#### City of Portland, Maine - Building or Use Permit Application 389 Congress Street, 04101, Tel: (207) 874-8703, FAX: 874-8716 Location of Construction: Phone: Owner: Permit No: \*\*\*130 Highland St. 15 Ptld. 04103 Matthew Danch 775-5935 991018 Lessee/Buyer's Name: BusinessName: Owner Address: Phone: sea Permit Issued: Contractor Name: Address: Phone: Homeowser COST OF WORK: PERMIT FEE: Past Use: Proposed Use: SEP 2 2 1999 \$ 1000.00 \$ 30.00 3 Unit 经被继续 **FIRE DEPT.** □ Approved INSPECTION: Use Group: P2Type:5 6 ☐ Denied BOCA96 Signature: Signature: Zoning Approval: 3 Proposed Project Description: PEDESTRIAN ACTIVITIES DISTRICT (P.A.D.) Action: Approved Special Zone or Reviews: 12 x 20 deck on let floor Approved with Conditions: ☐ Shoreland Denied ☐ Wetland 《 ☐ Flood Zone ☐ Subdivision® Signature: Date: ☐ Site Plan maj ☐minor ☐mm ☐ Permit Taken By: Date Applied For: Authy September 10, 1999 **Zoning Appeal** □ Variance This permit application does not preclude the Applicant(s) from meeting applicable State and Federal rules, ☐ Miscellaneous Building permits do not include plumbing, septic or electrical work. ☐ Conditional Use Building permits are void if work is not started wit

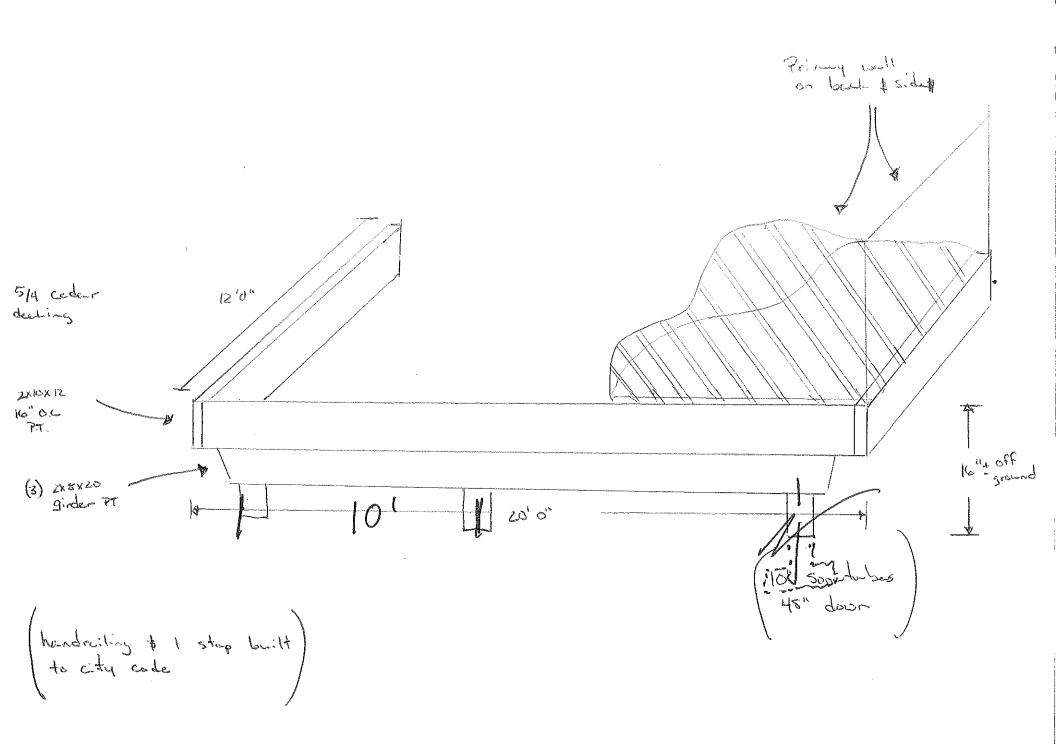
I am in receipt of your application to construct a 12' x 20' deck on the first floor. You plans show that you have a 14' setback instead of the required 20' setback. Your permit can not be issued unless the zoning ordinance requirements can be met. I do have the ability to allow a 15' rear setback if you can show me good cause as to why you can not meet the required 20' setback. In any case, you would need to adjust your plans to reflect the required setbacks.

Adjustments has 17,5' feet in Stead of 14 feet

tropedy lie 175') to rent property per pure Shill not be less Than 9/21/99 12'0" 15' zο' δ" Existing Howen 70' -10,5,7 Existing
Flower land
